### **GRUM SULPHIDE CELL COVER, FARO MINE**

### **2013 REVIEW**

**Re: 2013 Review – Grum Sulphide Cell Cover, Faro Mine**

**Figure 3-4. Ditch Section from Drawing G-12 (after SRK 2011)**

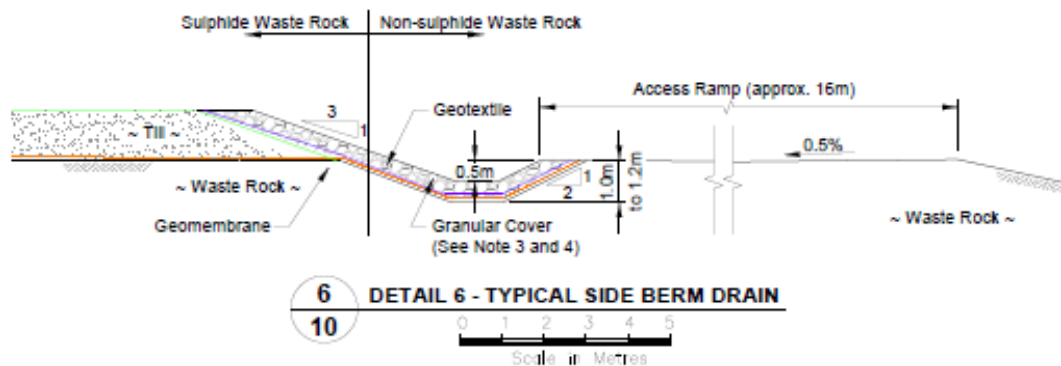
The as-built ditch section displays a wide ditch with at least one side slope of 3H:1V. As displayed in Photo 3-6, the side slope for the ditch section is much steeper in select locations, potentially approaching 1H:1V with a narrow bottom width. Such a narrow ditch is more easily blocked by slough material on the “cover” side and there are a few locations where this sloughing has occurred, see Photo 3-6. If this slough does not fully block the channel, it does restrict the flow which would be more easily affected by snow and ice blockages.

Given that the perimeter ditches and dissipation ponds appears to block and divert water during rapid snowmelt events, there are two courses to suggest. Firstly, YG and TEES should be prepared to remove all snow blockages from these ditches and dissipation ponds in the period immediately preceding run-off occurrence. Access for equipment may be an issue here. Secondly, it may be possible to modify the ditch design with some form of widening so that slough and snow blockage are less problematic. The perpendicular bend at the bottom of the two downhill ditches is likely also problematic and these hard bends in water direction should be avoided. Given the cost and construction aspects of channel modification in the short term, YG should be expecting to clear the perimeter ditch and ponds of any snow and ice blockages over the next few years until a final cover landform and channel design can be formulated and constructed.

**Photo 3-9. Two sloughs on the toe berm slope, just above the lined pond area (June 13, 2013).**

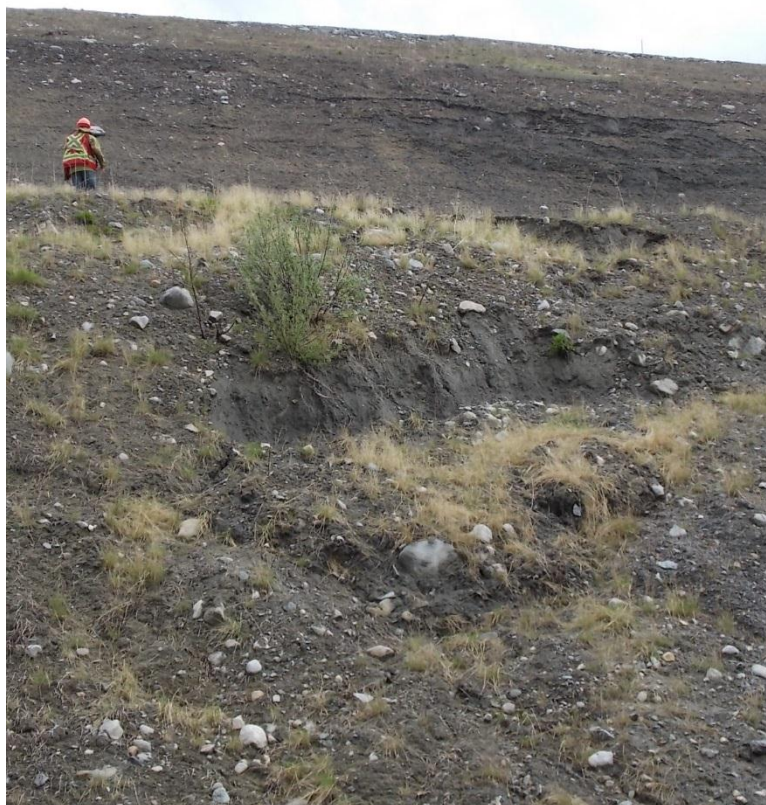
- Three sloughs located on the slopes directly over top of the lined pond. Two of these sloughs are shown on Photo 3-9.

These rills and sloughs are a function of water generated during freshet, the saturation of the subgrade caused by the previous climate and the local steepness of the slopes as they deviate from the 5:1 design slope. Not including the localized rills shown on Photos 3-4 and 3-5, the erosional rills and sloughs are generally located on slopes ranging from 3H:1 to 2H:1V on the toe berm downstream slope to perhaps as steep at 1H:1V on the side slope for the perimeter ditches.

- Regrade three sloughs on the slope near the toe berm, above the lined pond area. Two sloughs are located in the area where toe berm erosional gullies were previously repaired in 2011. Repairs must be carefully done to ensure minimal disturbance to the remaining slope and prevent further channelization of run-off and associated erosion. Erosion gullies should be filled with coarse material, to prevent further erosion of the fine grained till soil.
